Access Compliance Report Public Rights-of-Way (Curb Ramps)

Intersection ID: 28108 Main Street: BERITSTRASSE_CT Cross Street: DARBY_CHASE_DR Location: SW

ADA ID: C04FA303E9FA Ramp Type: Perp Initial Pass/Fail: Fail Overall Compliance: No Severity Score: 12.5

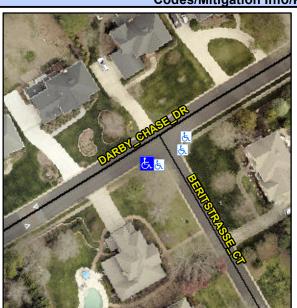
Not Found, R304.2.2

Field Measurements/Component Compliance					
Compliance Description		Data	Compliance Description		Data
N/A	Ramp Length (in)	48.0	No	Ramp Slope (%)	10.5
Yes	Ramp Width (in)	61.0	Yes	Ramp XSlope (%)	0.6
N/A	Flare Type LT	N/A	N/A	Flare Type RT	N/A
N/A	Flare Slope LT (%)	N/A	N/A	Flare Slope RT (%)	N/A
N/A	Flare Traversable LT?	N/A	N/A	Flare Traversable RT?	N/A
N/A	Landing Length (in)	N/A	N/A	DWS Provided?	N/A
N/A	Landing Width (in)	N/A	N/A	DWS Contrast?	N/A
N/A	Landing Slope (%)	N/A	N/A	DWS Length (in)	N/A
N/A	Landing X Slope (%)	N/A	N/A	DWS Full Width?	N/A
N/A	Landing Curb? (Y/N)	N/A	N/A	DWS Offset (in)	N/A
N/A	Shared Landing?	N/A			
N/A	Gutter Ponding?	N/A	N/A	Gutter Slope (%)	N/A
N/A	Gutter Lip Ht (in)	N/A	N/A	Gutter X Slope (%)	N/A
N/A	Painted X Walk1?	No	N/A	Painted X Walk2?	N/A
	X Walk 1 Direction	To NW		X Walk 2 Direction	N/A
N/A	X Walk 1 Width (in)	N/A	N/A	X Walk 2 Width (in)	N/A
	X Walk 1 Slope (%)	2.4		X Walk 2 Slope (%)	N/A

Remove & Replace Entire Ramp.
